Architectural Review Board

Staff Report

Subject: 145 Hawthorne Avenue [12PLN-00072]: Request by Zach Trailer for Architectural Review of the construction of three detached residential units on a 10,503 sq. ft. lot. Zone District: RM-15. Environmental Assessment: Exempt from the provisions of the California Environmental Quality Act (CEQA) per CEQA Guidelines Section 15332.

1 TYPICAL EAVE
NTS

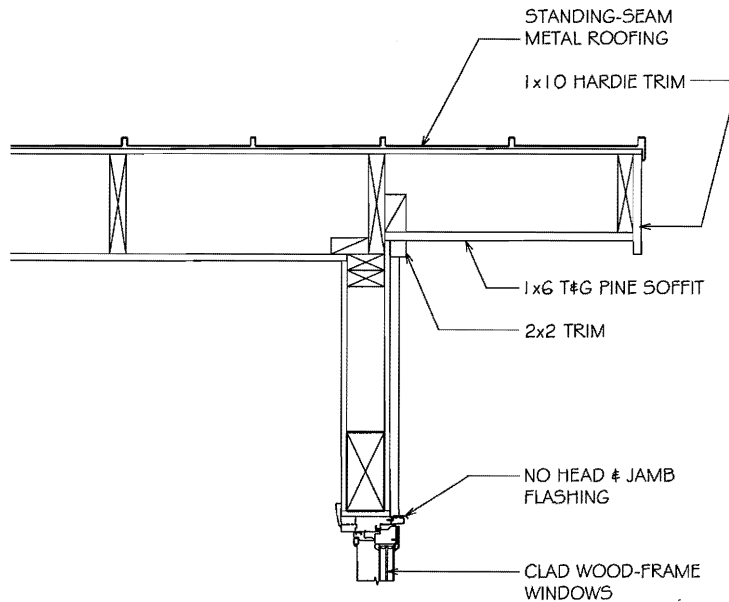
- Lighting detail cut sheets;
- Landscape Plan;
- Fence details;
- Rafter tail details;
- Trash receptacle location;
- Downspout location shown on elevations;
- Removal of the copper flashing material;
- Articulation of the side elevations of Units 2 and 3;
- A view of Unit 3 from the driveway;
- Larger eaves on Unit 3;
- Contextual elevations of the unit; and
- Connectivity to the bike storage area.

- Attachment H provides a fence detail indicating the new 4’ open rail fence, the 4’ fence and the 6’ fence with 12” open rail slats.
- Attachment I provides rafter design details.
